## **SCONE AERODROME SAFETY INSPECTION**

# **SCONE AERODROME**

## **AERODROME SAFETY INSPECTION**

**6 and 7 February 2019**

Photo 3 – Runway 11/29 crack patching

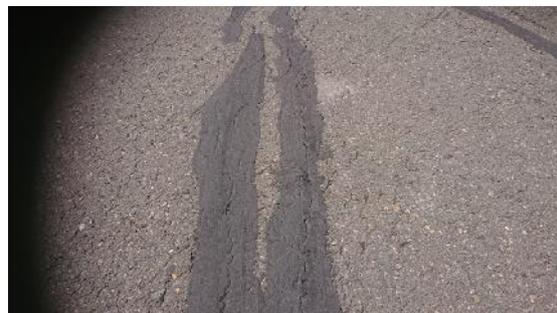
There are many joints within the asphalt section that have now opened up due to shrinkage, and a number of cracks have appeared on the edges of the pavement, some have had weeds growing in them.

The cracking in the pavement is now so extensive that it is unlikely that a crack sealing program will rectify the problems and provide a water proof surface. The larger cracks should be sealed to prevent the ends fretting off and producing FOD and any vegetation growing in the cracks should be removed.

- Recommendation 1** *The Kamen Engineering report “Pavement Investigation, Assessment, Maintenance and Rehabilitation Scone Regional Airport”, dated 22 December 2017, should be implemented as soon as possible.*
- Recommendation 2** *If it not possible to implement the Kamen Engineering report within 12 months, another solution should be developed with appropriate engineering advice to protect the pavement. One such treatment could be a 10 mm bitumen seal over the asphalt section of the runway.*
- Recommendation 3** *Seal all the large cracks to prevent the edges fretting and producing FOD penetrating into the pavement.*
